CHANGED 44R02-4111-150 TO 44R02-4111-250. (RFB)			
1	9250	12/31/97	RE
REV	ECN	DATE	APV
THIS PRINT IS THE PROPERTY OF ITS CORP. IT SHALL NOT BE COPIED WITHOUT PERMISSION.			
MATERIAL		TITLE	
---		AC DISTRIBUTION ASSY, EXC. CAB. (1245-1500)	
FINISH		DWG. NO.	
---		1245-8500 1	
REV		SCALE 1=1	
ECN		SHEET 1 OF 1	
DATE		REV	
APV		1	
DWN		5/28/98	
CHK		5/28/98	
REL		5/29/98

TITLE I/C AC DISTRIBUTION
ASSEMBLY, (SINGLE PHASE)
(1278-1200)

DWN	TMY	12/11/96	DWG. NO.	REV
CHK	RE	12/13/96	1278-8200	2
REL	RE	12/13/96	B	SCALE---

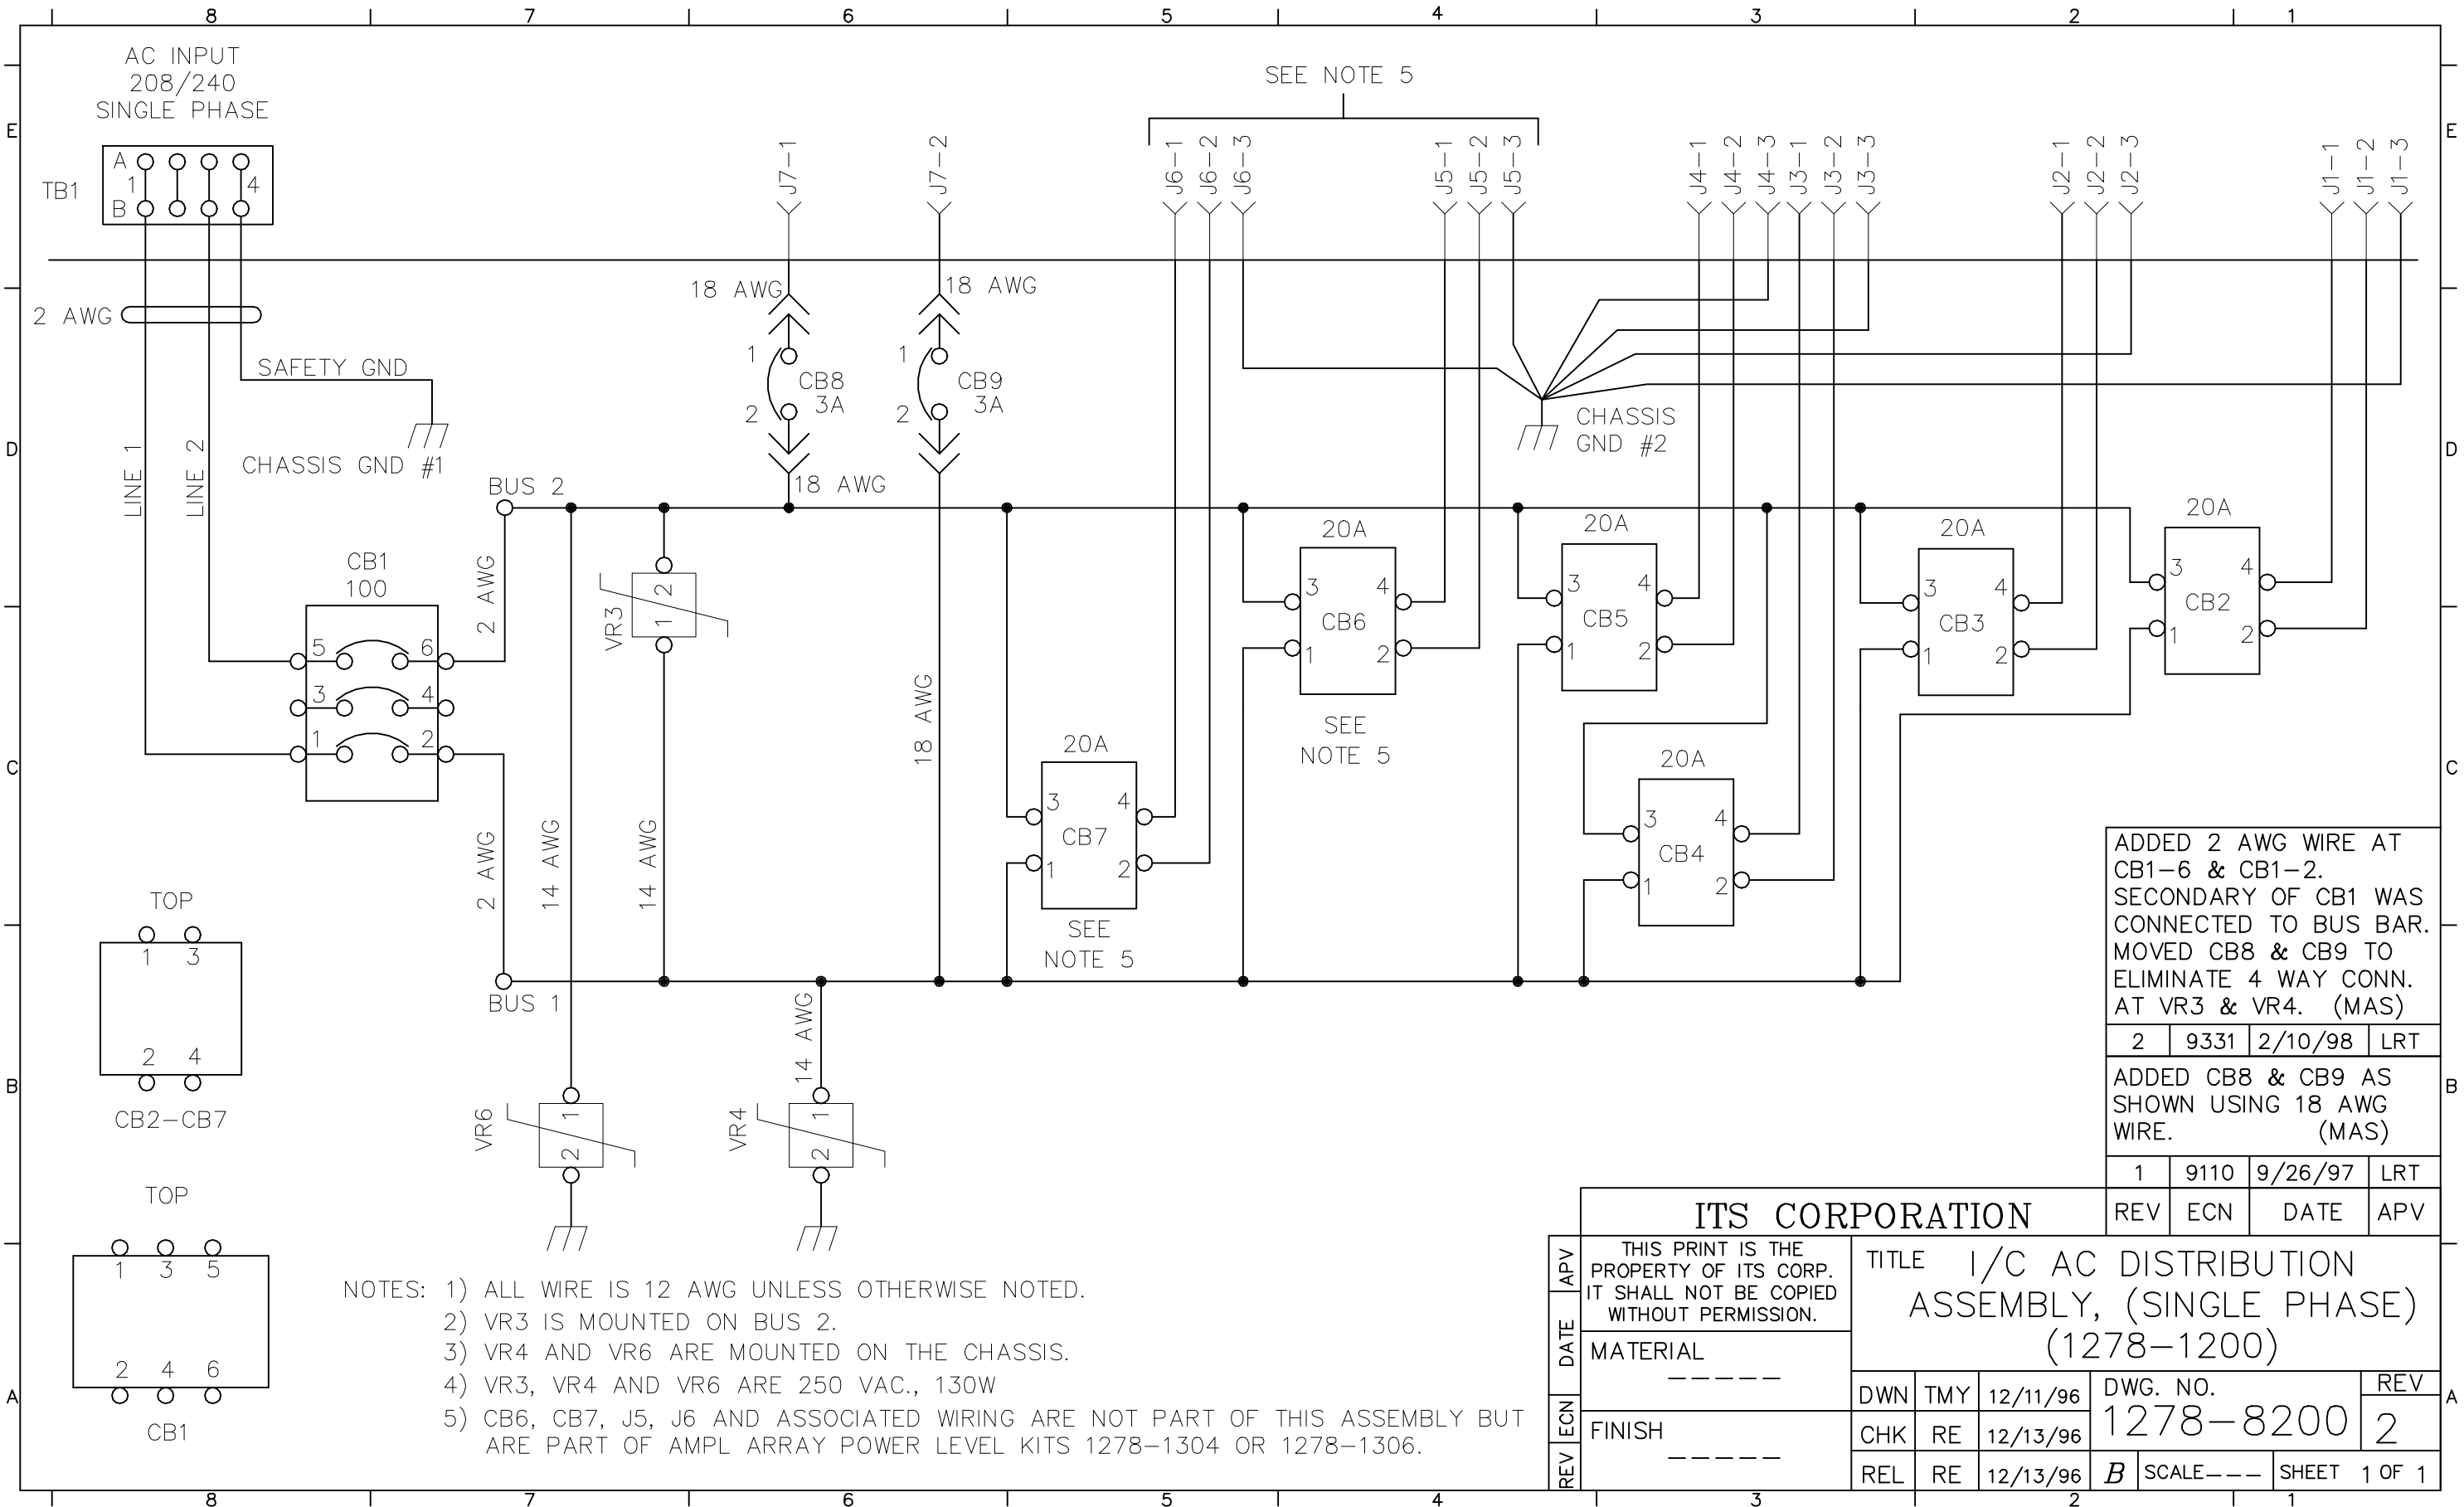
ADDED 2 AWG WIRE AT
CB1-6 & CB1-2.
SECONDARY OF CB1 WAS
CONNECTED TO BUS BAR.
MOVED CB8 & CB9 TO
ELIMINATE 4 WAY CONN.
AT VR3 & VR4. (MAS)

ADDED CB8 & CB9 AS
SHOWN USING 18 AWG
WIRE. (MAS)
